Access Compliance Report Public Rights-of-Way (Curb Ramps)

Main Street: SHADOW_HILL_DR Cross Street: KELLOGG_DR Location: NW

ADA ID: RPAT210922133553 Ramp Type: Type 1 - Perpendicular Diagonal Initial Pass/Fail: Pass Overall Compliance: No Severity Score: 46

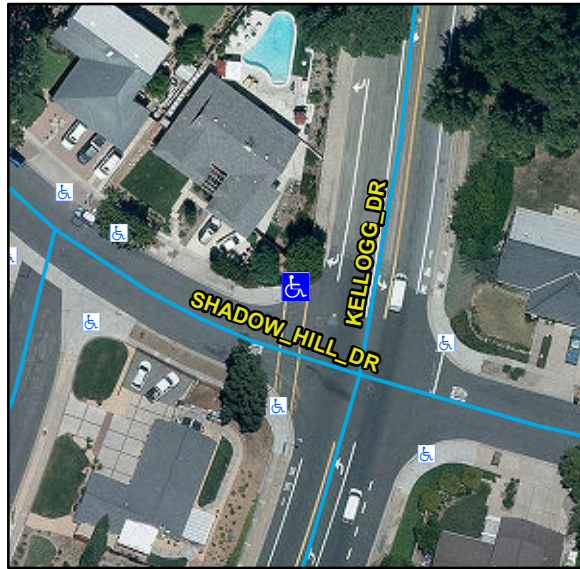
Compliance	Description	Data	Compliance	Description	Data
N/A	Ramp Length (in)	44	N/A	Flare Type LT	
Yes	Ramp Width (in)	48			Sloped
Yes	Ramp Run Slope (%)	0	Yes	Flare Slope LT (%)	8
No	Ramp Cross Slope (%)	10.8	N/A	Flare Traversable LT	Yes
N/A	Landing Present	Yes	N/A	Flare Type RT	
N/A	Landing Length (in)	43			Sloped
Yes	Landing Width (in)	48	No	Flare Slope RT (%)	11.6
Yes	Landing Run Slope (%)	1.7	N/A	Flare Traversable RT	Yes
No	Landing Cross Slope (%)	10.2	Yes	DWS Provided	Yes
N/A	Landing Movement Obstructed?	Yes	Yes	DWS Contrast	Yes
	Landing Movement Type	Curb	Yes	DWS Length (in)	36
N/A	Landing Shared	No	Yes	DWS Full Width	Yes
N/A	Clear Space	Yes	Yes	DWS Offset Left (in)	0
N/A	Clear Space To Crosswalk (in)	48	Yes	DWS Offset Right (in)	N/A
N/A	Marked Crosswalk 1	Yes	N/A	Marked Crosswalk 2	No
	Crossing 1 Direction	S		Crossing 2 Direction	E
	Marked Crosswalk 1 Width (in)	120		Marked Crosswalk 2 Width (in)	N/A

Yes	Ramp Inside Crosswalk 1	Yes	Yes	Ramp Inside Crosswalk 2	N/A
	Crossing 1 Slope (%)	5		Crossing 2 Slope (%)	9.2
	Crossing 1 Cross Slope (%)	13.9		Crossing 2 Cross Slope (%)	3.3
Yes	Gutter Ponding	No	N/A	Curb Slope	1.8
Yes	Gutter Lip Height (in)	0		Road Run Slope (%)	9.5
No	Gutter Run Slope (%)	5.6		Road Cross Slope (%)	5.8
No	Gutter Cross Slope (%)	8.4			
Yes	Overall Surface Condition: Acceptable		Yes	Perp Joint Present	Yes
	Cross Gutter Present?	No		Spandrel Present?	No
	Replace Cross Gutter?	N/A		Replace Spandrel?	N/A

Remove & Replace Curb Ramp With Two New Directional Ramps or Equivalent. Remove & Replace Gutter.
